## STAFF REPORT ADDENDUM

APPLICATION SE 2009-DR-008

**APPLICANT:** Oakcrest School

**PROPOSAL:** Approval of a special exception for a Private School of General Education with a maximum daily enrollment of 450 students (grades 6-12)

**CROWELL ROAD ENTRANCE DETAIL**

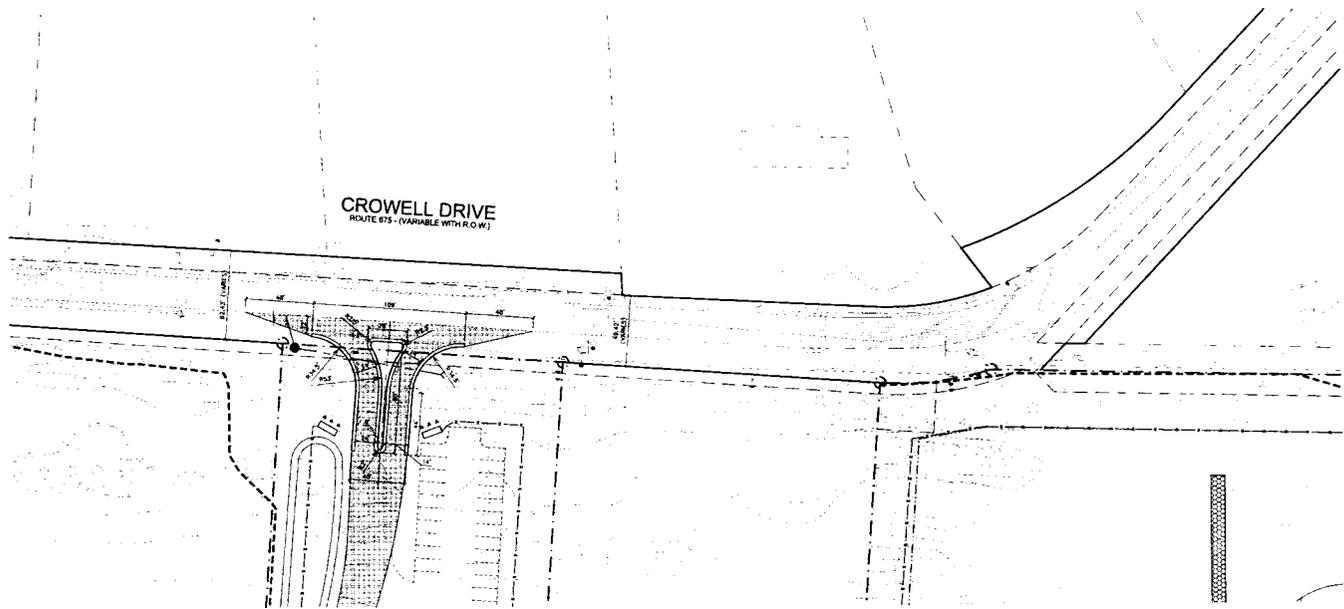
It should also be noted that the SE Plat appears to show an off-site sign located along Hunter Mill Road, in addition to wall features and signs located on-site at the edge of the property along the access to Hunter Mill and at the Option B Crowell Road entrance. Off-site signs are not permitted, and as a special exception use, the application would be governed by Sect. 12-208 Par. N, which permits only one building mounted sign and one freestanding sign, each with a maximum sign area of 12 square feet and with a combined total sign area of no more than 20 square feet. Staff has proposed a new condition stating that, irrespective of that shown on the SE Plat, signage shall conform to Sect. 12-208 of the ordinance.

The applicant's analysis indicates that either of the proposed entrance configurations will function, so long as the traffic circle is installed. Because of the high percentage of traffic coming to the site from the Toll Road (and returning to the Toll Road), the traffic circle is essential. Without the circle, that traffic would have no place to U-turn to return to the Toll Road. Staff therefore recommended that, if for some reason at final design the traffic circle could not be installed, the applicant should be required to return for a special exception amendment to amend their plan and reevaluate the entrances and the traffic network. In response, the applicant has proposed that the original entrance configuration for Crowell Road (full access) be included as an option. Staff has therefore proposed a development condition that states that, if the traffic circle is not approved, a signal will be installed and full access will be provided to Crowell Road, as shown in the attachments.
